PRODUCT CHANGE NOTICE:

SIZE	DESCRIPTION:	REV.
C	FREESTANDING PERGOLA SUPPORT POST CHANGE NOTICE	A
SCALE: NONE	DATE: 9/29/2020	© TEMO SUNROOMS INC. SHEET 1 OF 1

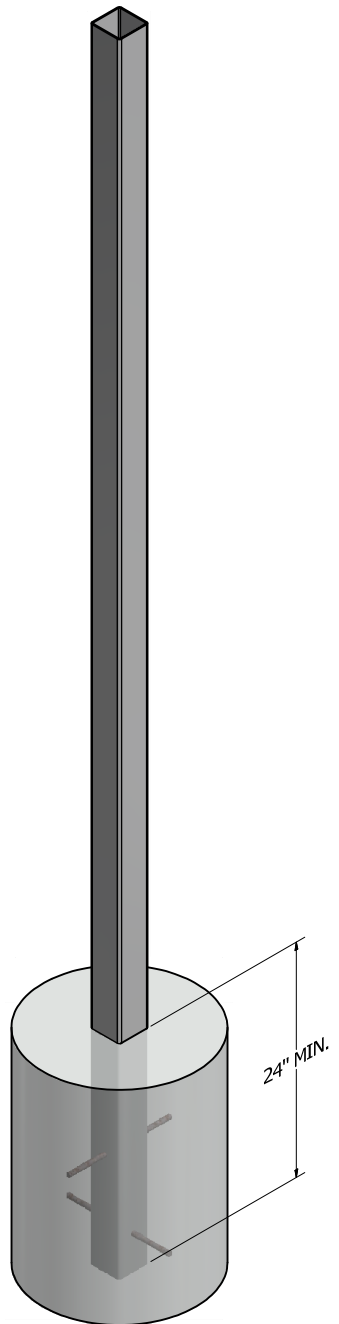
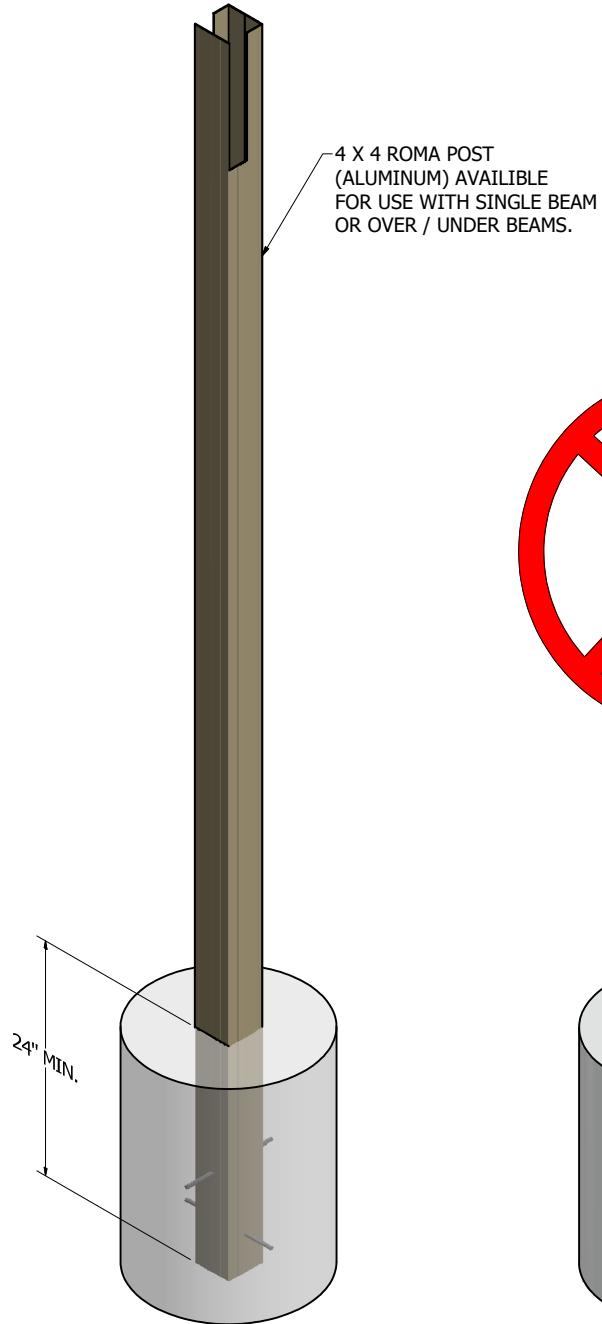
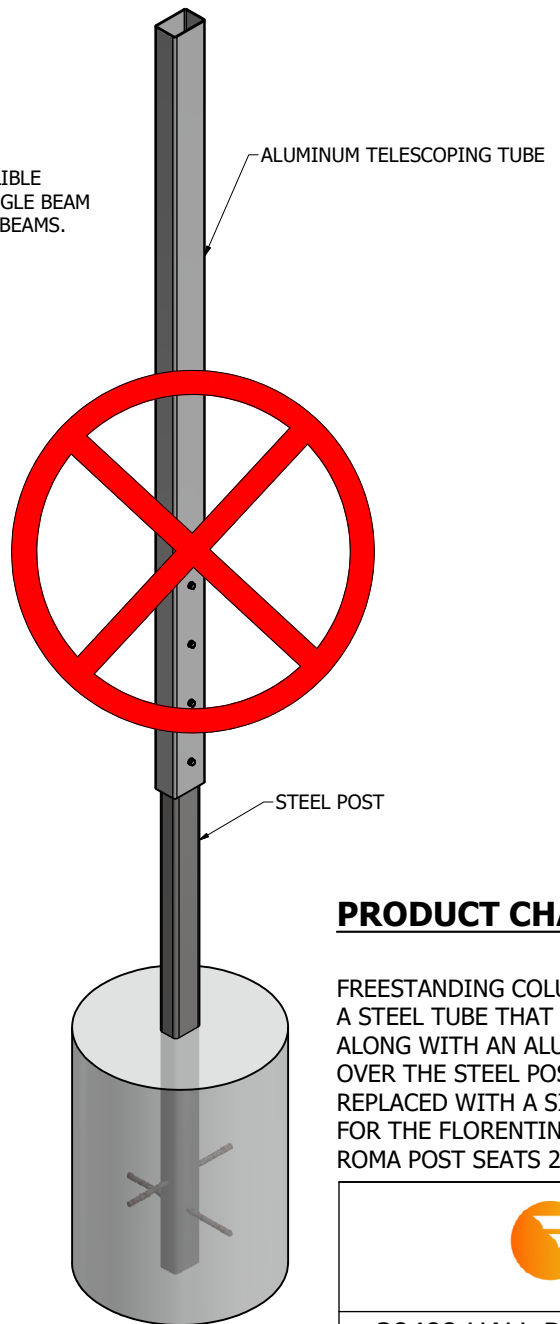
FREESTANDING COLUMNS PREVIOUSLY INCLUDED A STEEL TUBE THAT WAS FIXED IN PEIR / FOUNDATION ALONG WITH AN ALUMINUM TUBE THAT WOULD TELESCOPE OVER THE STEEL POST FOR ADJUSTABILITY. THIS DESIGN IS REPLACED WITH A SINLGE 3 1/2" ALUMINUM SQUARE TUBE FOR THE FLORENTINE AND VENETIAN COLUMNS. THE NEW ROMA POST SEATS 24" MIN. IN CONCRETE FOUNDATION.
